MANDATORY SERVICE BULLETIN
MSB 42-099/1
MSB 42NG-035/1
supersedes MSB 42-099 & MSB 42NG-035

Inspection / replacement of spherical rod end bearing and safety washer of nose landing gear (NLG) actuator, P/N X11-0006/2 with S/N 0155 and below.

WI-MSB 42-099

WI-MSB 42NG-035

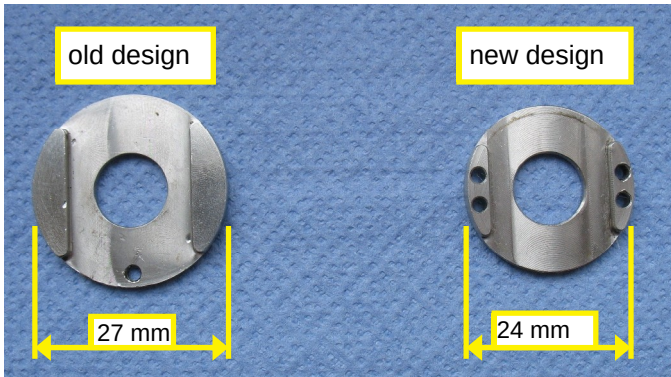
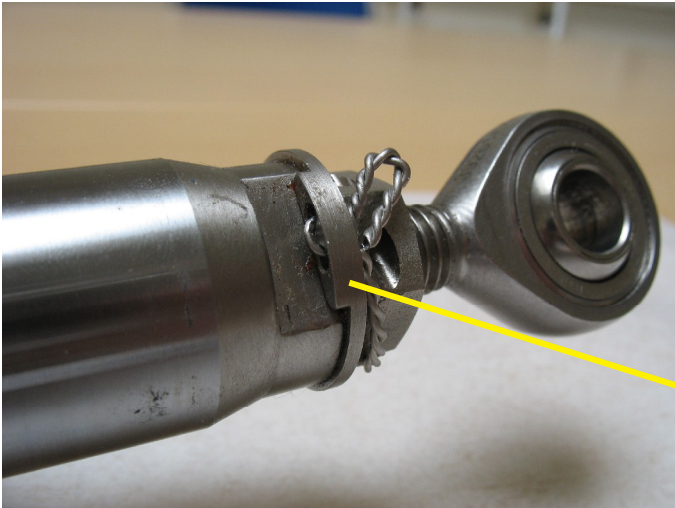
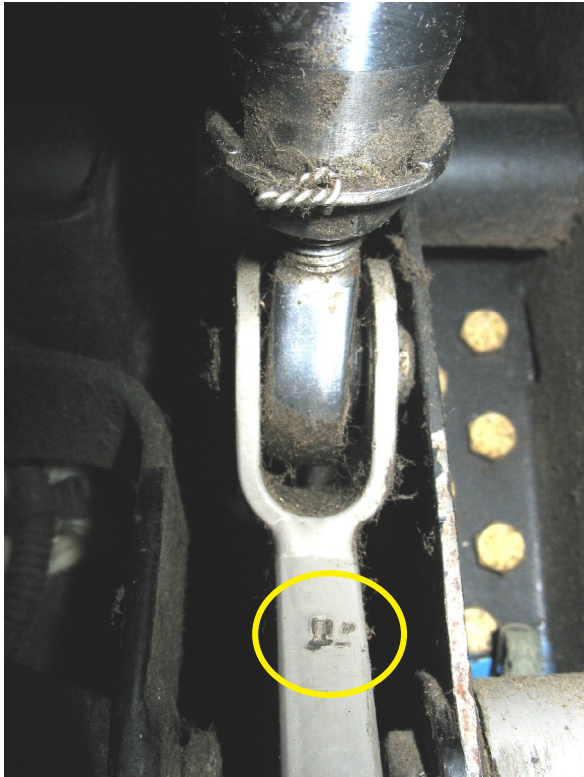
Identify part number (P/N) and serial number (S/N) of nose landing gear (NLG) actuator (use inspection mirror).

safety washer

rod end bearing

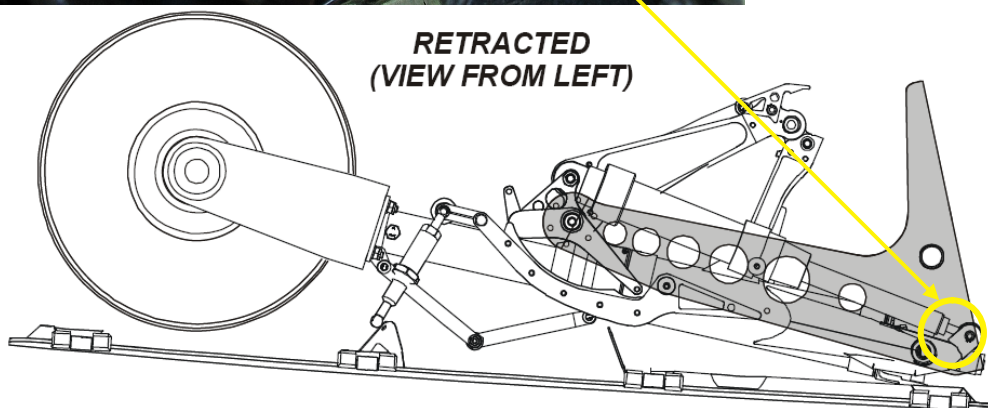
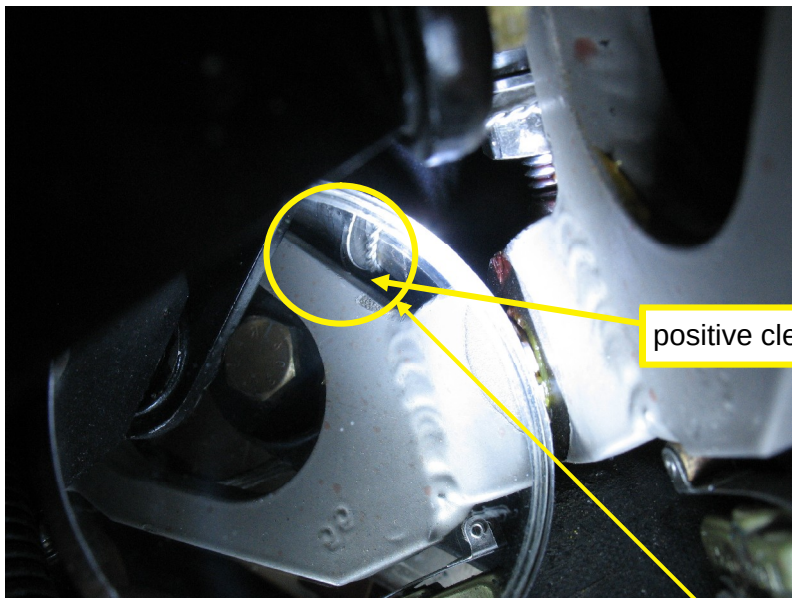
2	If NLG actuator has P/N X11-0006/2 and S/N is 0156 or higher, proceed with item 12.
3	If NLG actuator has P/N X11-0006/2 and S/N is 0155 or lower remove NLG actuator from the aircraft in accordance with AMM, section 32-20. NOTE: It is not necessary to remove the actuator completely from the aircraft. The following work can be done with the actuator remaining connected to the NLG brace assembly and to the hydraulic system.
4	Remove spherical rod end bearing from the NLG actuator piston in accordance with AMM, section 32-30. Discard spherical rod end bearing.
5	Measure diameter of safety washer. Possible diameters are: - 27 mm (old design, picture on the left) - 24 mm (P/N X11-0006-00-00.02, Rev B, new design, picture on the right). 
6	If diameter of safety washer is 27 mm replace it with one of the new design with 4 holes for lock wire and with reduced diameter of 24 mm, P/N X11-0006-00-00.02, Rev B.

8	Secure the counter nut with lock wire. Route the lock wire through both holes on one side of the safety washer, as shown in the picture. Lock wire must not be routed over the circumferential edges of the safety washer as lock wire might reduce clearance between safety washer and actuator attachment lever at the NLG leg.  safety washer
9	Complete information on sticker with date and name of maintenance organization. Clean area of the sticker's size on the NLG actuator with clean and fresh acetone and apply it to the NLG actuator. Cover sticker with transparent protection foil. modified acc. to MSB 42-099 / MSB 42NG-035 Safety Washer replaced by P/N X11-0006-00-00.02, Rev B Date: _____ Name: _____
10	Reinstall NLG actuator in accordance with AMM, section 32-30.
11	Apply anti-corrosion coating on actuator connections in accordance with AMM, section 12-30.

7	Re-assemble NLG actuator with a new spherical rod end bearing, in accordance with AMM, section 32-30.
